RE: Civic Design Review Key Recommendations to Guide Second Submission
PERMIT #: ZP-2023-013424
309 W Mount Pleasant Avenue

The following architectural comments in regards to 309 W Mount Pleasant Avenue 'Civic Design Review Package' submitted for the proposed development at 309 W Mount Pleasant Avenue, Philadelphia, PA 19119, have been received by CosciaMoos Architecture. The CDR plans, renderings, forms, etc. have been revised per said comments as follows. The responses to the comments are typed in **blue**.

11/06/2024
309-21 W MT PLEASANT AVE
PHILADELPHIA, PA 19119

SITE PLAN KEY

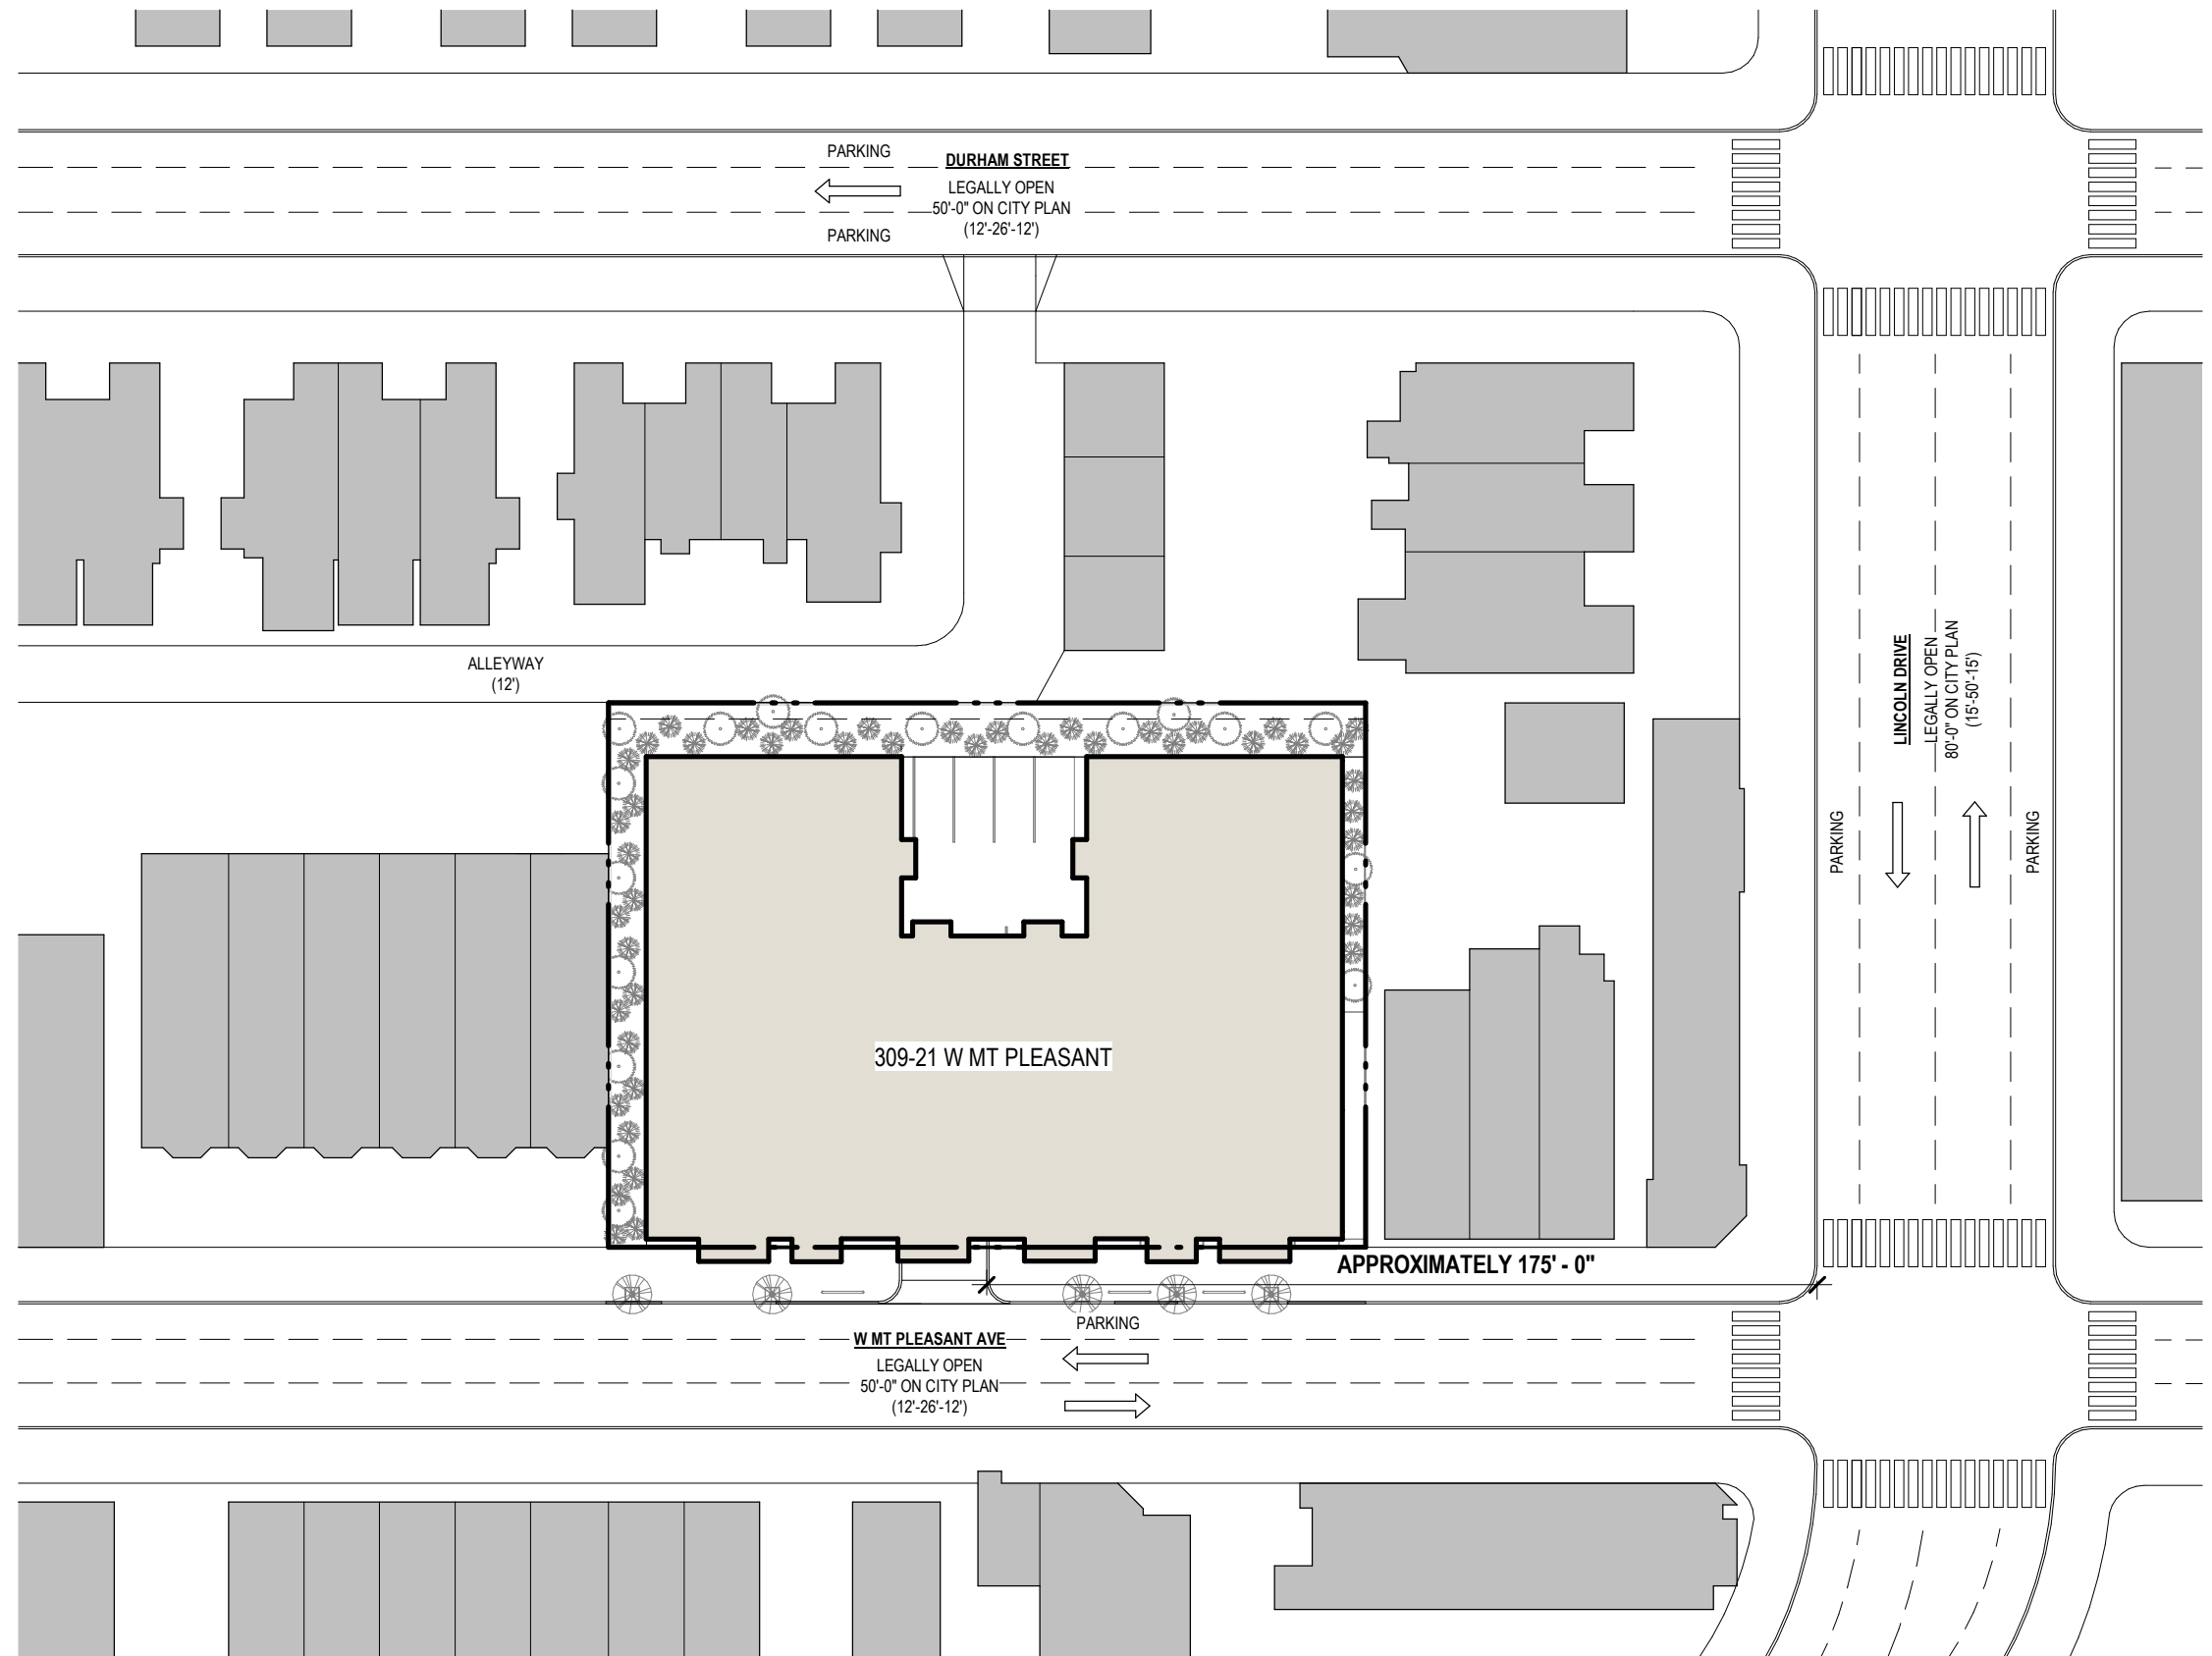
The parking entrance is too close to Lincoln Drive – consider moving it to the other side of the building.

Shift the curb cut away from Lincoln Drive.

CosciaMoos Response: The parking entrance has been relocated plan west and is now approximately 175'-0" away from Lincoln Drive. See page 07 in the CDR Package for this dimension.

LANDSCAPE LEGEND

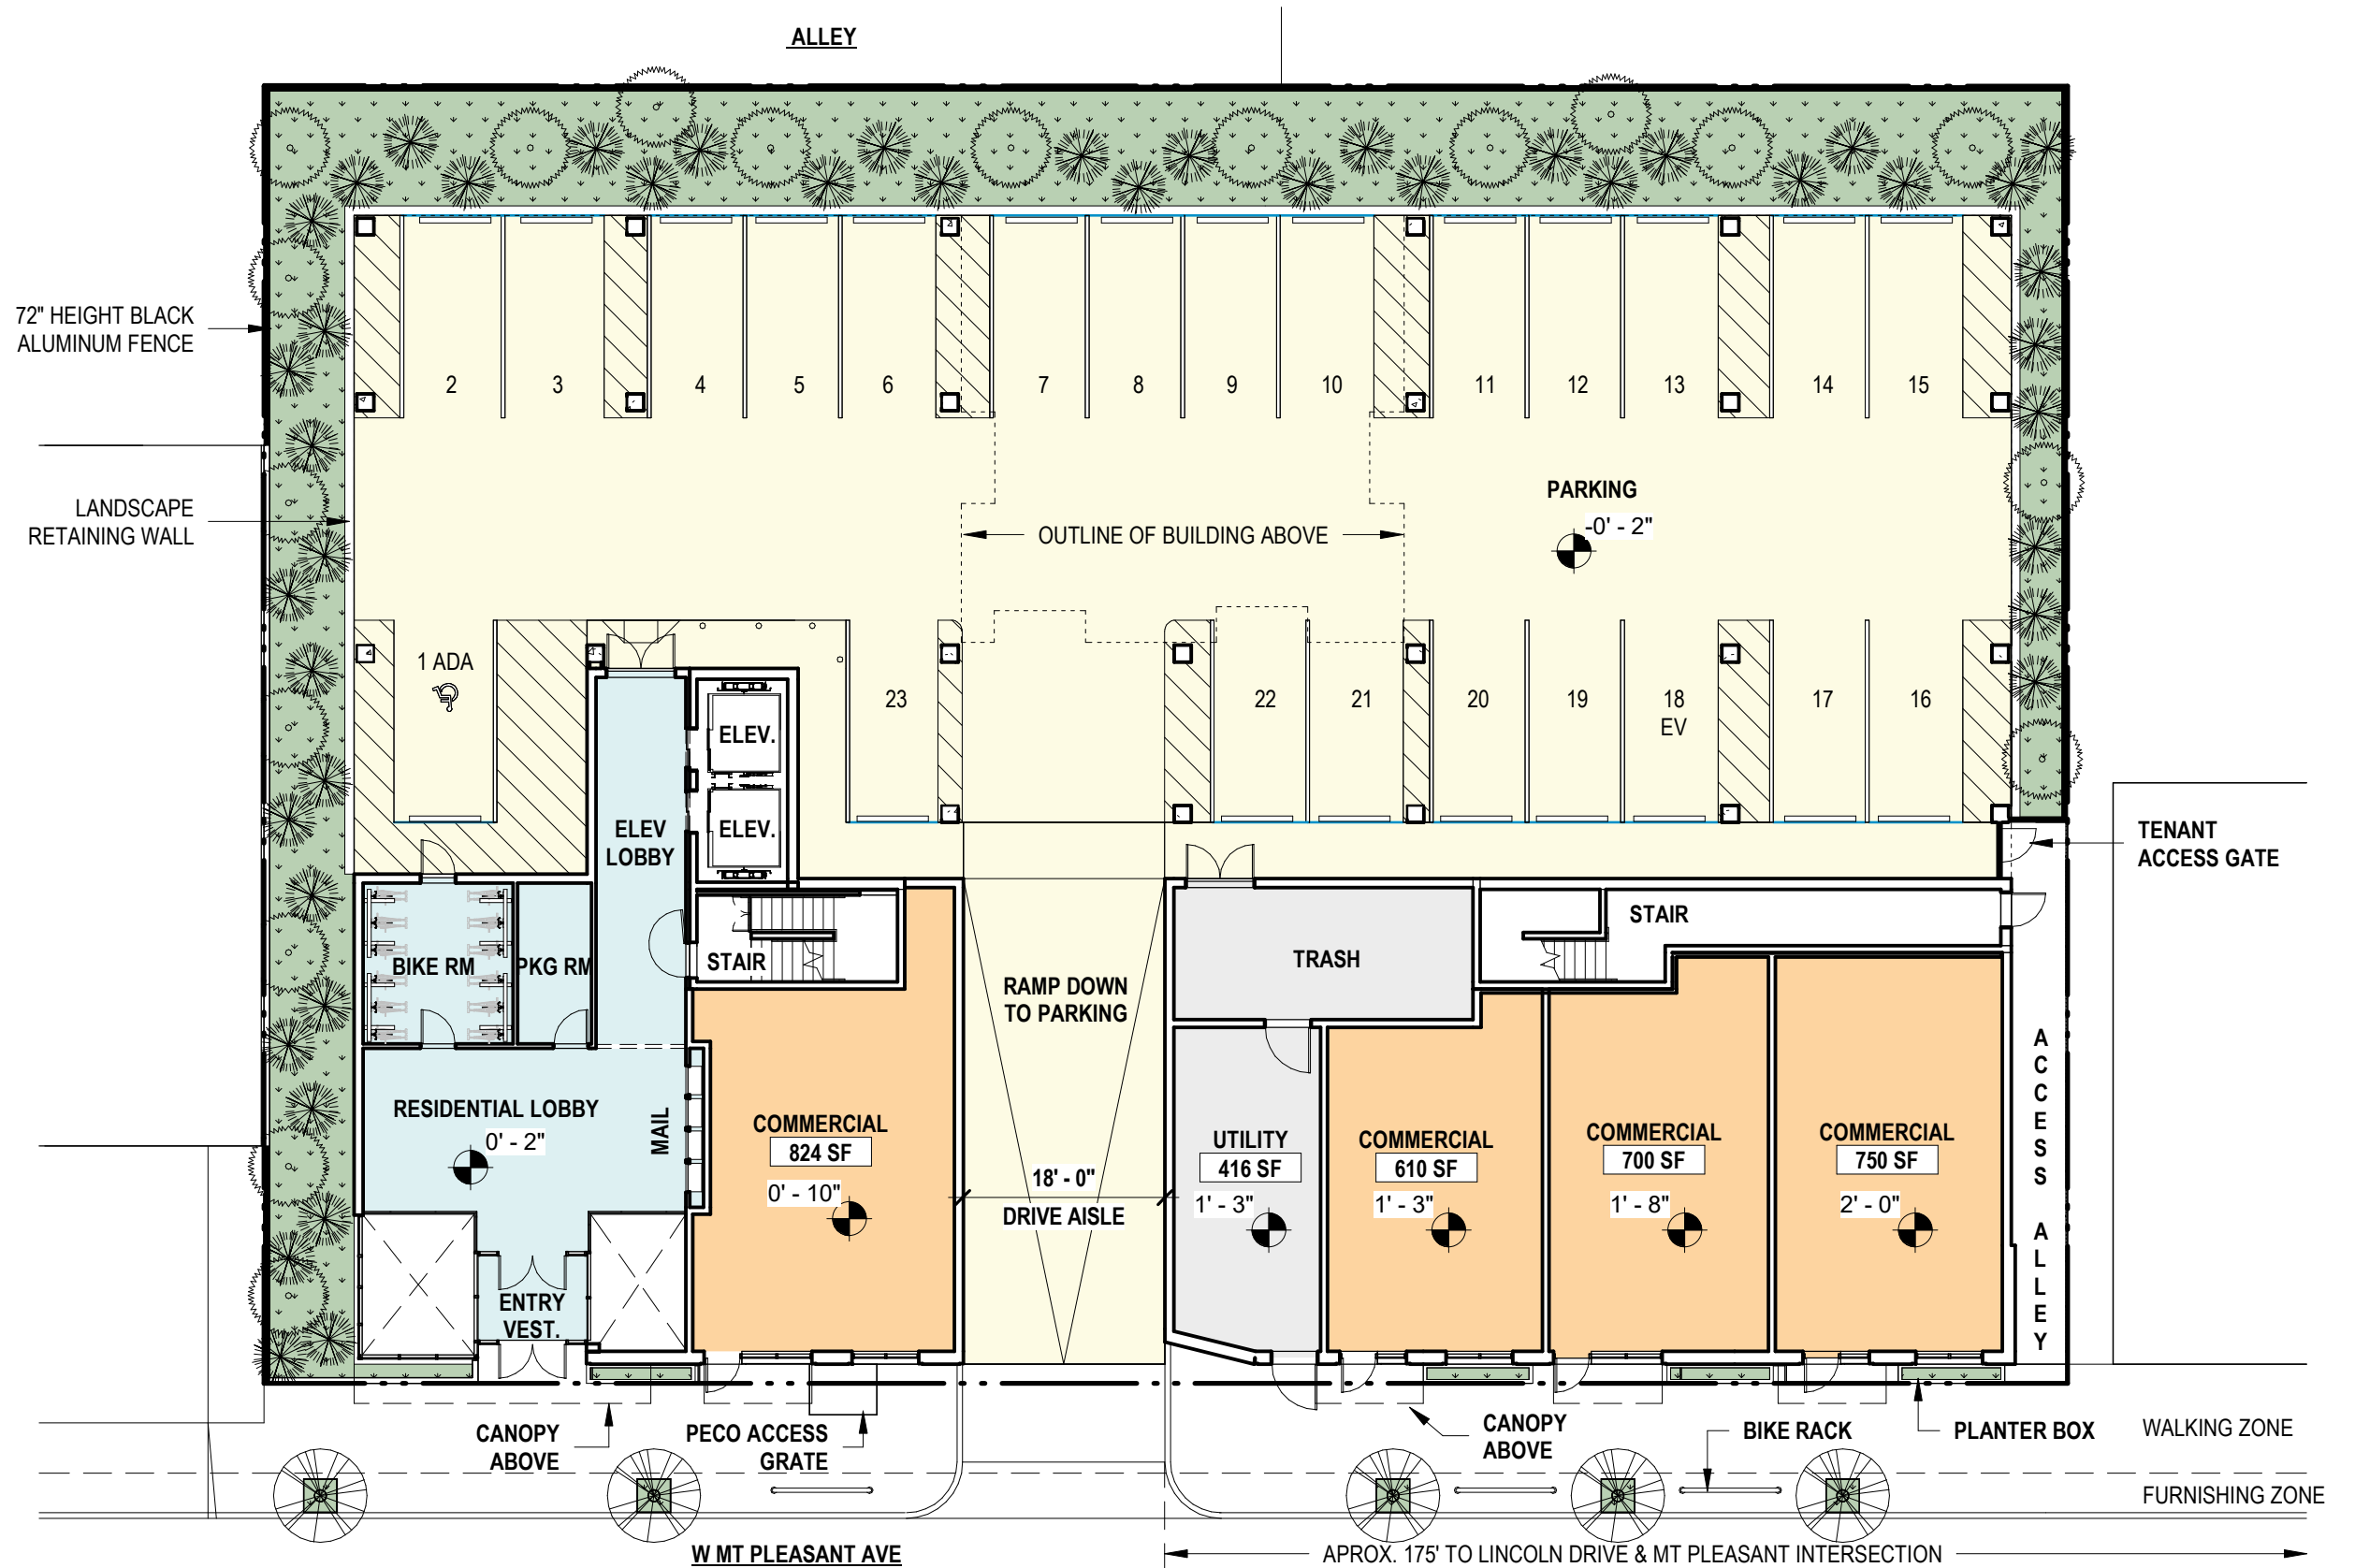
Please show all complete street dimensions on plans and indicate where planters are located.

The plant pallet is too simple – add more diversity.

CosciaMoos Response: Walking Zone, Furnishing Zone, and planters added to plan, see page 09 in the CDR Package.

PLAN LEGEND

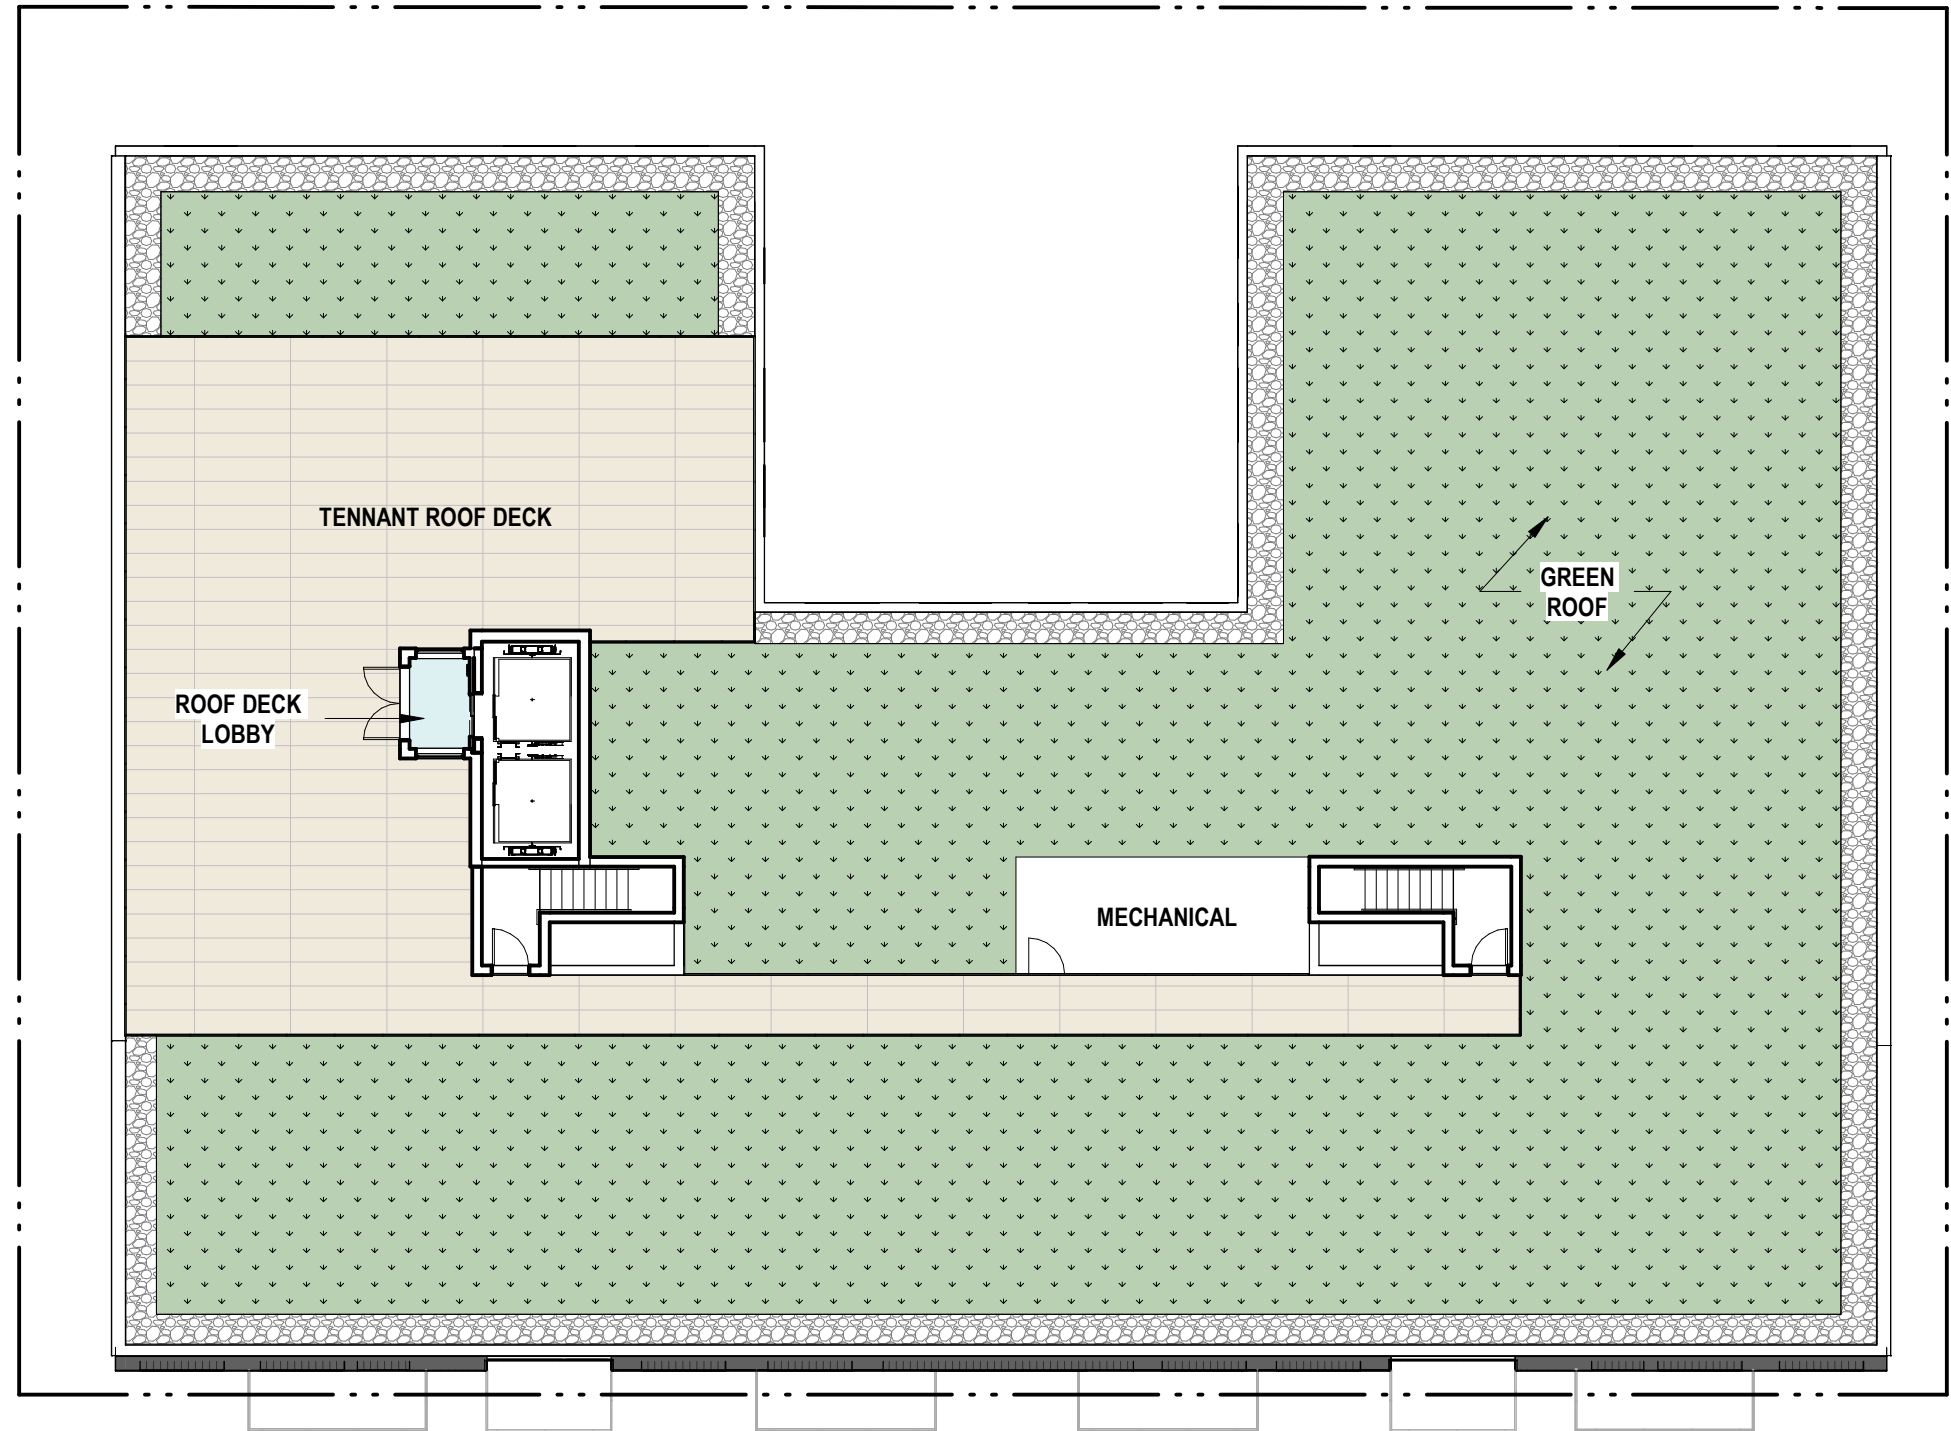
Move the roof deck away from the neighboring properties.

CosciaMoos Response: The roof deck has been redesigned accordingly, see page 14 in the CDR Package.
